**REVIEW OF ECOLOGICAL ASSESSMENT BY JAMES WARREN &
ASSOCIATES FOR A PROPOSED EXPANSION OF BP AUSTRALIA SITE
AT CHINDERAH: LOT 1 DP 1127741 AND LOT 2 DP 1010771**

Vegetation Assessment and Options

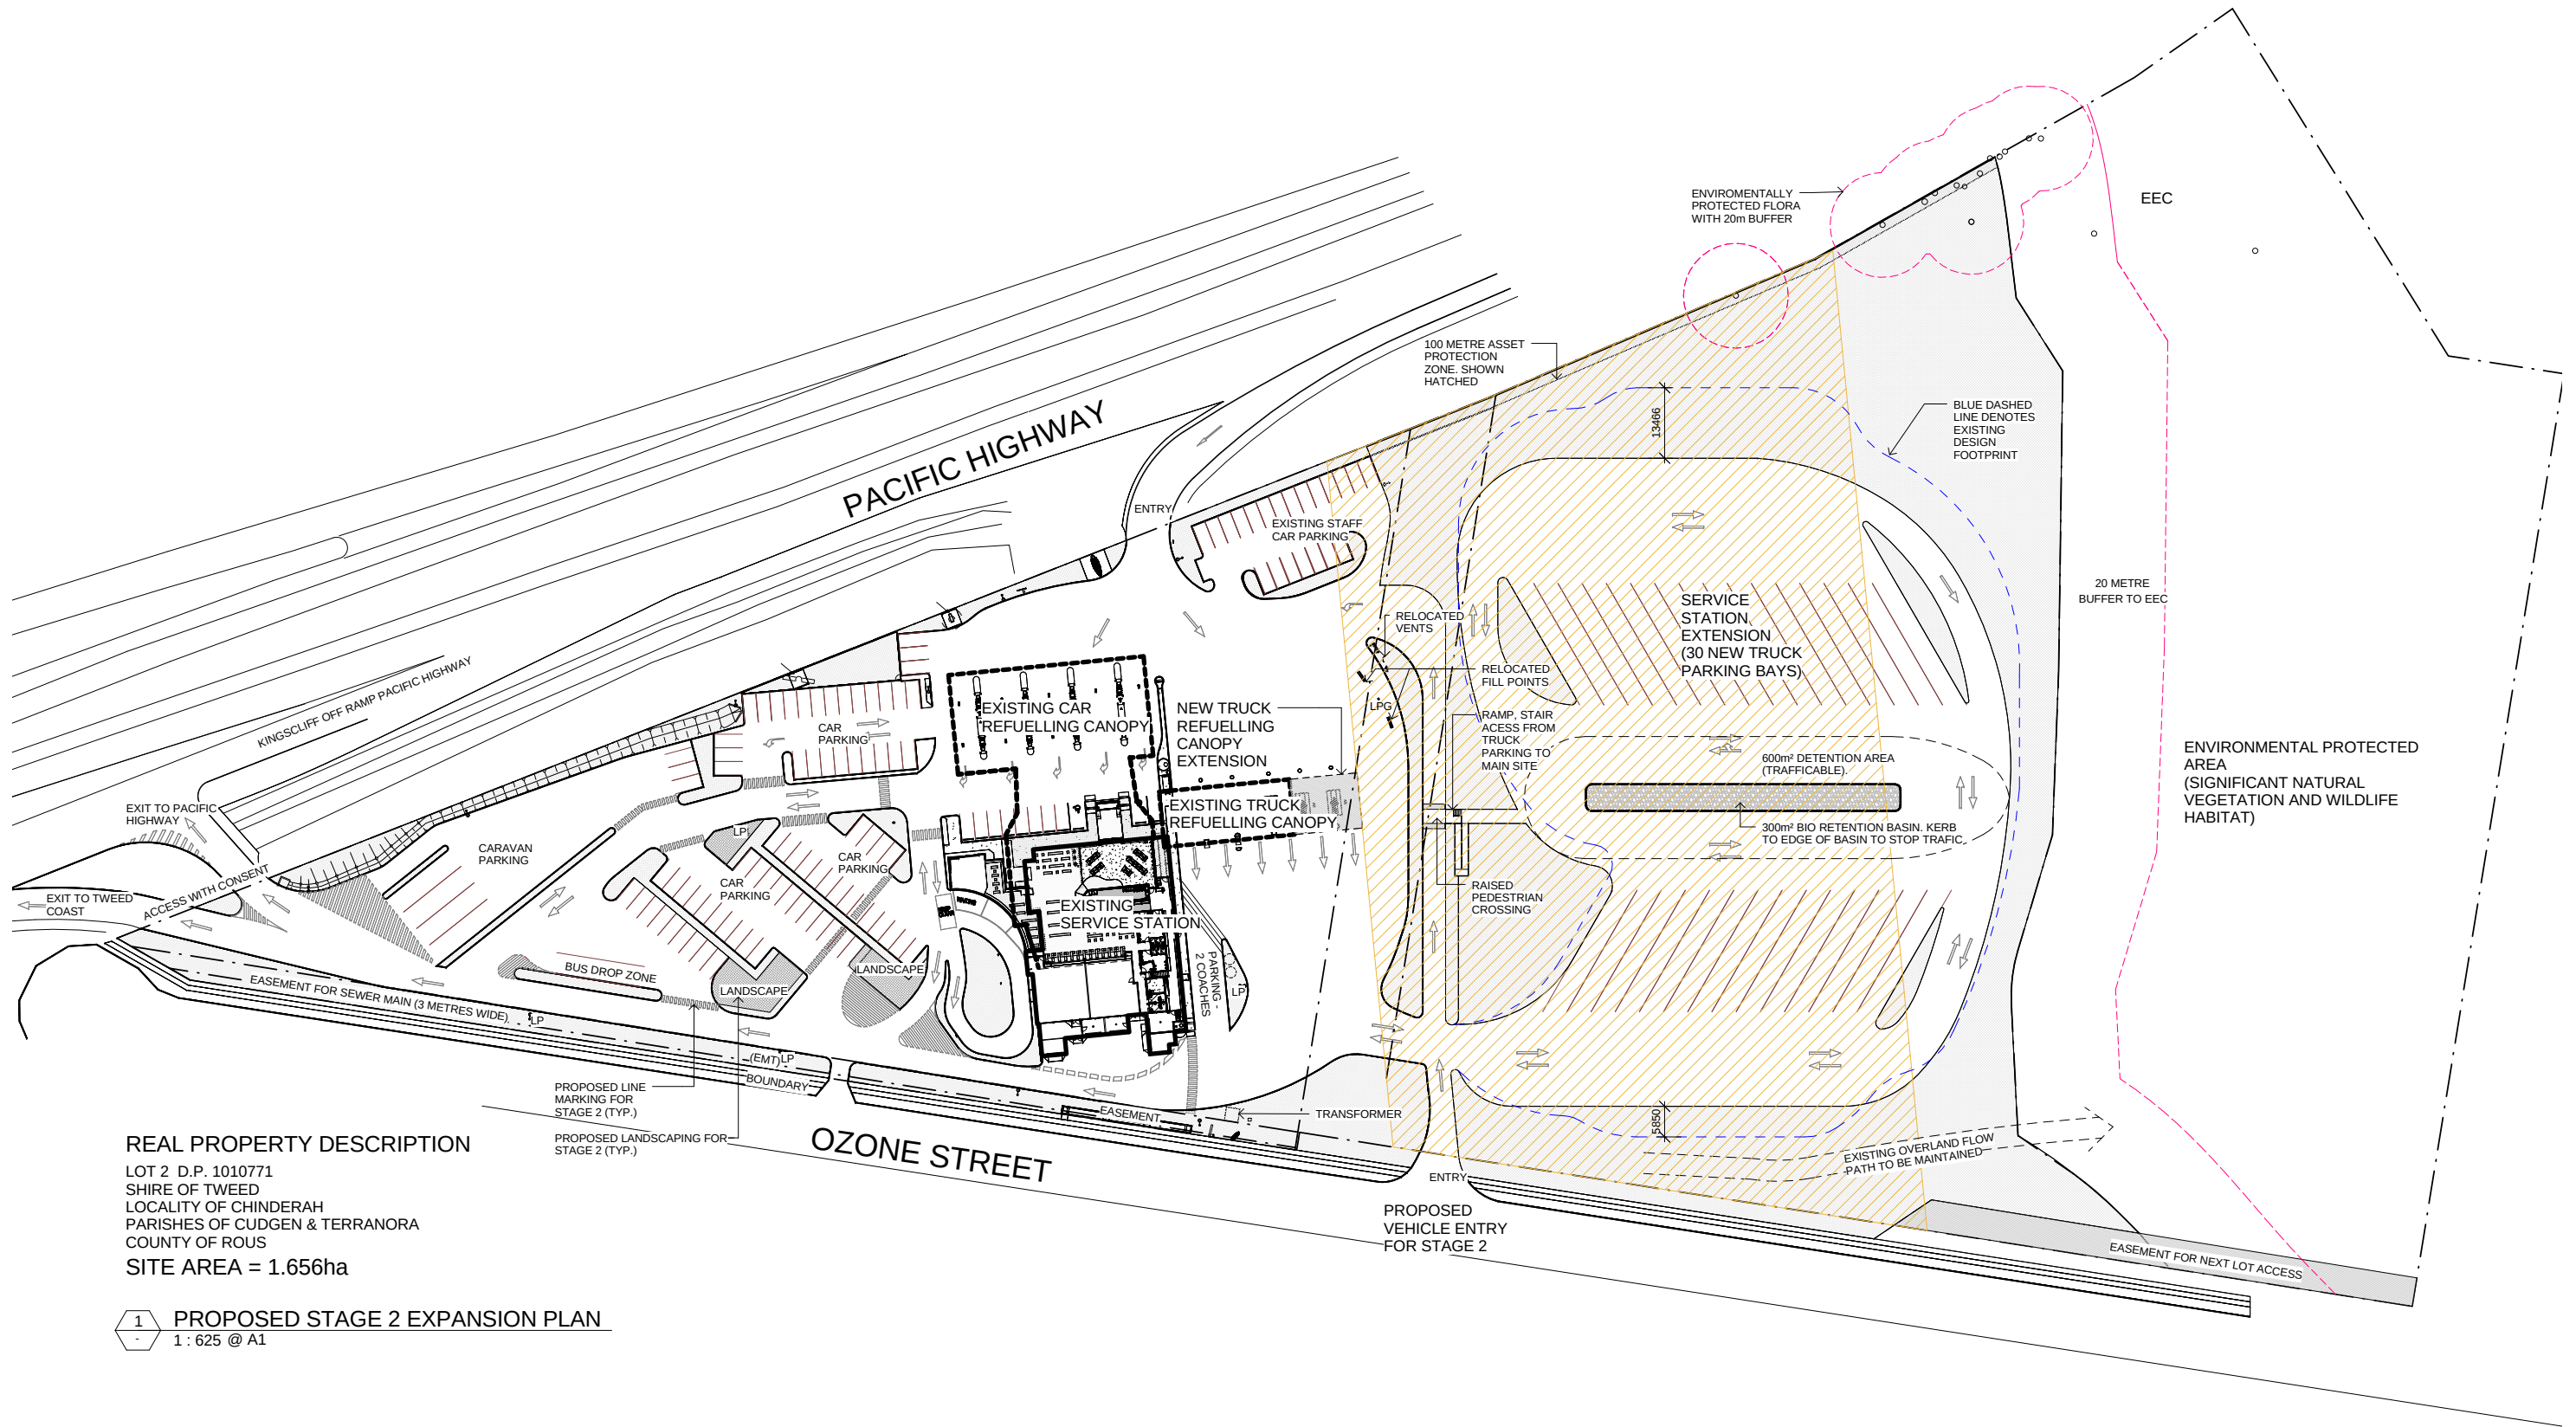
The options for a reduced footprint have been based on the minimal number of truck parking bays that are feasible, with a reduction from 33 to 30, which allows for a reduction in vegetation clearing from either the north, east or south, as shown in the plans presented in **Appendix B** to this letter. The greatest ecological outcome is indicated to result from Option 3, as this will increase the buffer to the Conservation Area and TECs present. These options are provided to Council for further discussion.

It is our opinion that the onsite offsets being provided as part of the proposal, with or without a minor modification to the Proposal (as set out in this letter) would result in an acceptable environmental outcome on the site.

SITE LAYOUT - PROPOSAL E (OPTION 1)

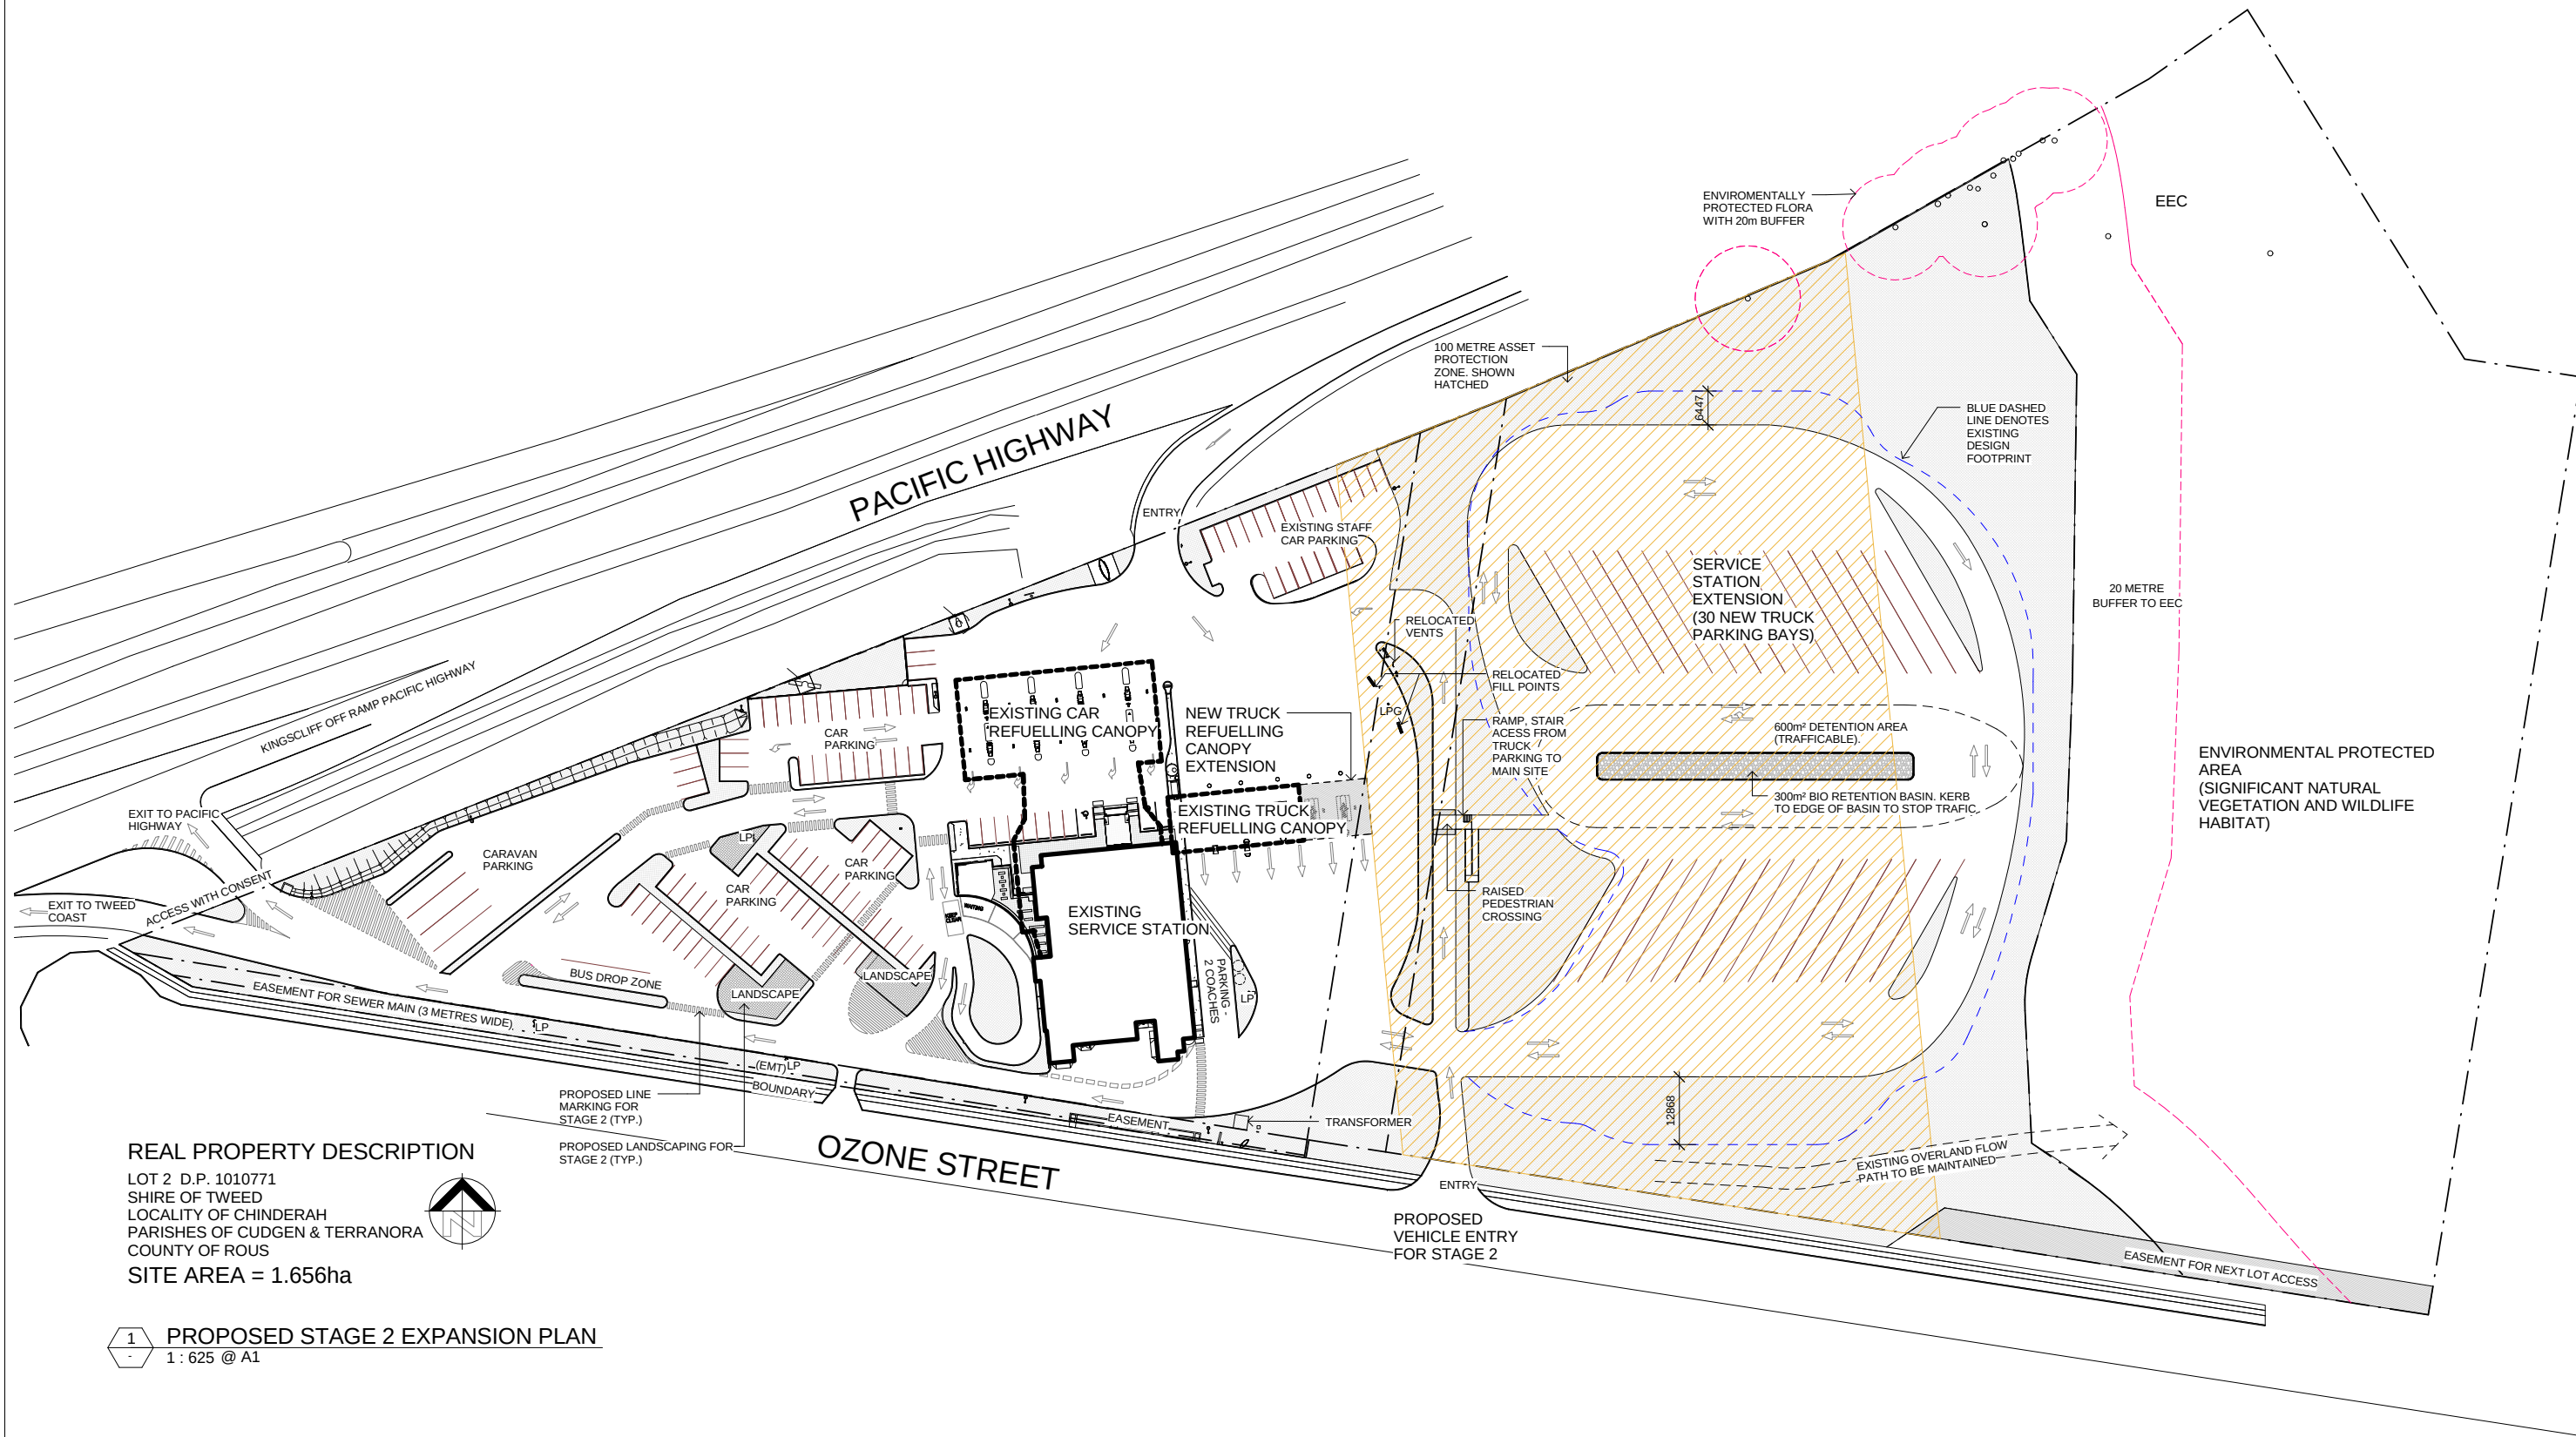
- Option 1: reduction in the area of vegetation removed from the southern boundary to minimise impacts on the more intact representative of Community 5, which contains a greater number of mature *Lophostemon confertus* and *Corymbia intermedia* trees than the central portion of the Subject Site;

Option 1 is likely to allow for the retention of the greatest number of mature trees, as per the Mature Trees Plan (James Warren & Associates 2013), however, the narrow strip of vegetation

present is bounded by Ozone Street, and does not connect to a corridor of vegetation to the south or west.
